# Sacramone Park

## City of Everett ADA Transition Plan

August 2018

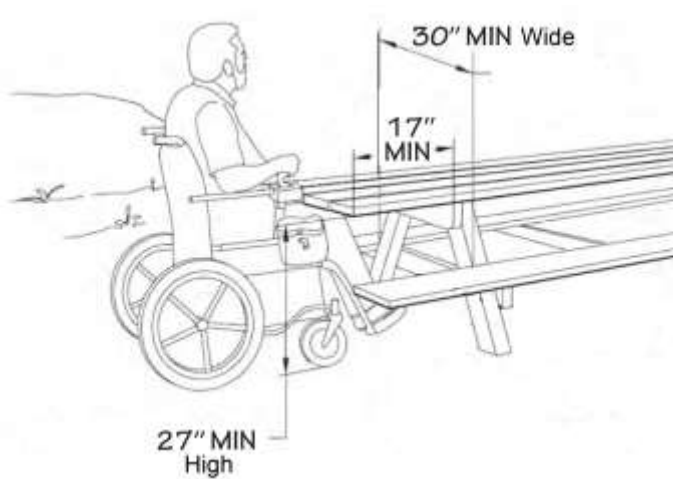
The service counter window for the concessions stand is located higher than 36 inches above the finish floor.

Team seating area illustration.

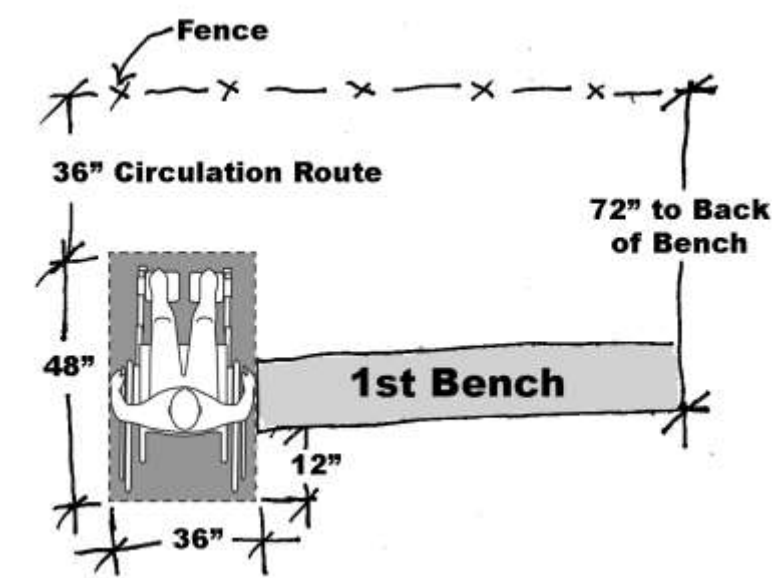
No space is provided for a wheelchair user to sit alongside their peers in any of the four (4) baseball dugouts.

ADA 2010 and MAAB toilet room height details.

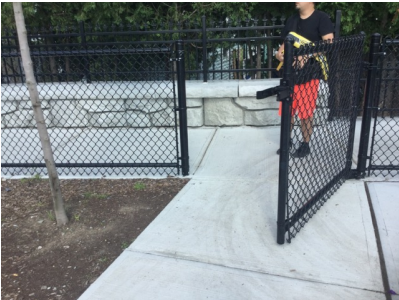
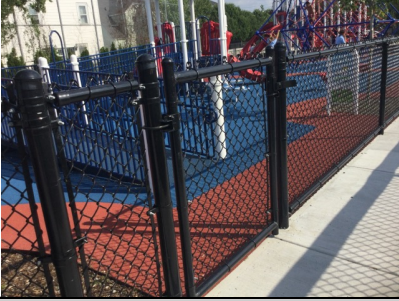
Size of accessible compartments and clear space at urinals and lavatories at Sacramone Park Field House Permit Set from 03-15-2018 is drawn in compliance with ADA standards and MAAB code. Some details are not called out, such as the location and heights of fixtures, accessories and grab bars within the toilet rooms. Location of toilet paper dispenser is represented incorrectly in toilet room drawings based on 2010 ADA Standards: it should be located 7"-9" in front of the rim of the toilet. The rim of the urinal should be mounted no higher than 17" above finished floor and the flush control should be no higher than 44" above finished floor. Included is a diagram outlining heights of other items in a toilet room per MAAB and ADA 2010 Standards:
